1962 Corvette: Service Bulletin: Aluminum Powerglide Shift Problems

Source: Chevrolet Technical Service Bulletin

Bulletin No: DR #514

Date: January 16, 1962

FIGURE 1- 327 AND 283 POWERGLIDE TV LINKAGE COMPARISON

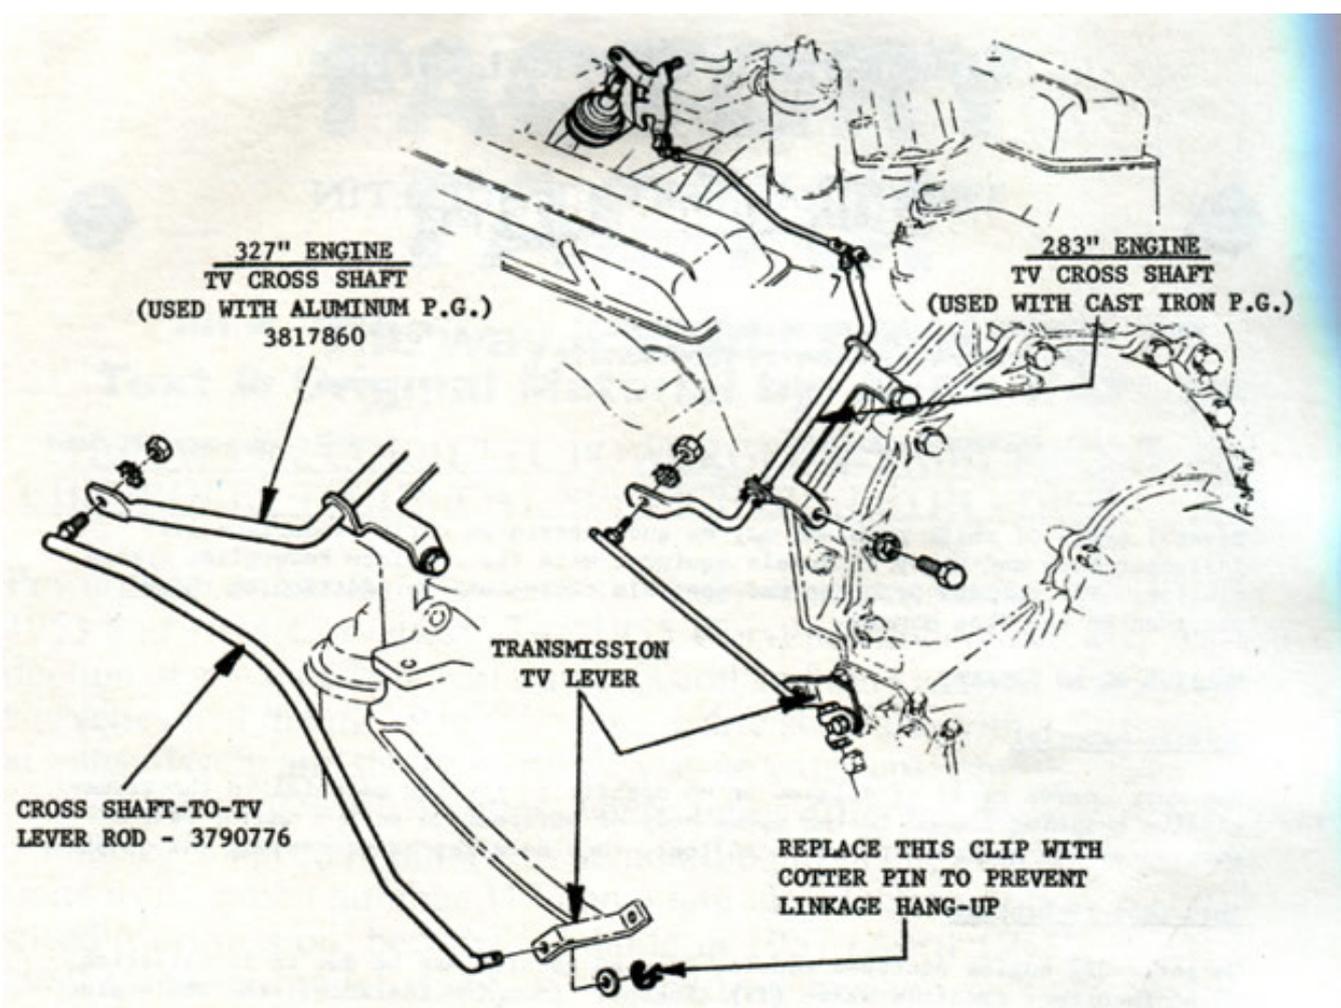
Incorrect TV Linkage

On early 327 engine equipped models, delayed upshift may be due to installation of an incorrect throttle valve (TV) linkage. In a few instances, the 283 engine cross shaft was installed instead of the correct TV cross shaft, 3817860. The TV cross shaft are easily identified as the 283 version has a bend in its outboard lever whereas the 327 cross-shaft lever is straight in this same area. (Figure 1). If the TV cross shaft was incorrect, also check the cross shaft-to-TV lever rod. As shown in Figure 1, this rod, 3790776, is formed on 327 engine applications as compared to the straight rod used on 283 engine versions.

Cross Shaft, TV (327 engine) ---- 3817860

Rod, Cross Shaft-to TV (327 engine) ----- 3790776

FIGURE 2 - ALUMINUM POWERGLIDE DIPSTICKS

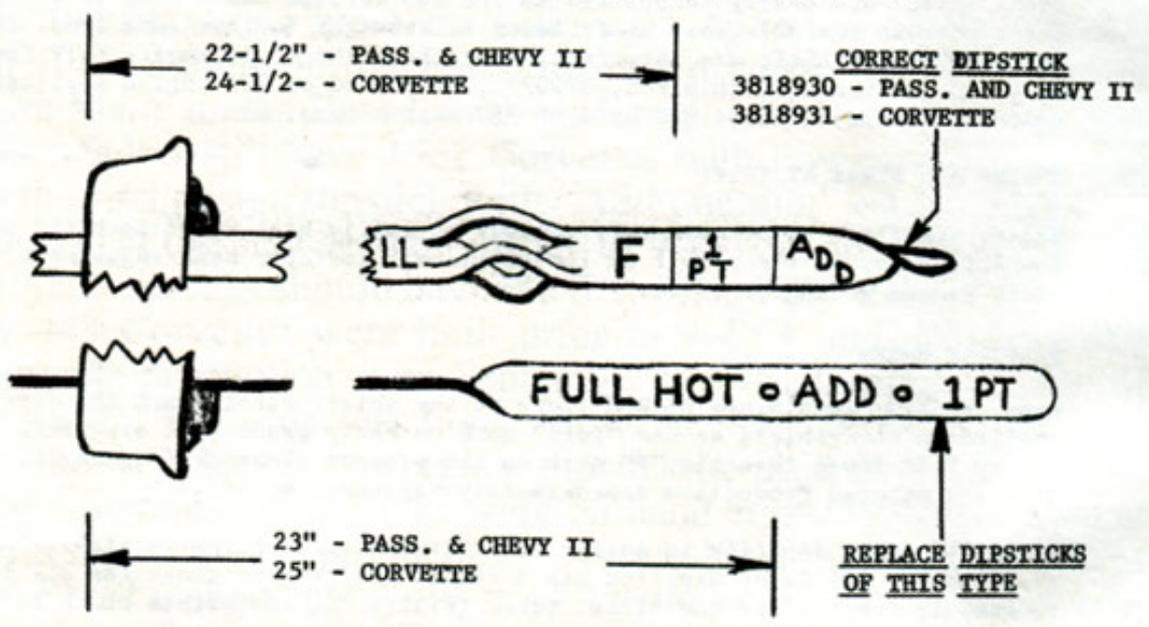
Dipstick Usage

When checking complaints of RPM flare at the shift, first check the dipstick installed in the vehicle as the "Full" mark on early production dipsticks is approximately 1/2" lower than the "F" mark on the present dipstick (Figure 2). The later dipstick entered Production approximately September 4, 1961.

The early style dipstick is easily identified as its bottom section is absolutely flat whereas the later dipstick has a formed bridge just above the oil level markings to keep it centered in the filler tube. (Figure 2). A further check is to measure the distance from the top of the cap to the "Full" mark; on

Passenger and Chevy II dipsticks, this distance is now 22-1/2", as compared to 23" on the earlier dipsticks. This distance on the Corvette dipstick is now 24-1/2" as compared to 25" on earlier units.

Replace all early dipsticks with the later part when found and add oil as

required to raise the transmission oil level to the "F" mark. The later dipstick for 327 engine passenger cars and all Chevy II Models is 3818930; for Corvette, 3818931.
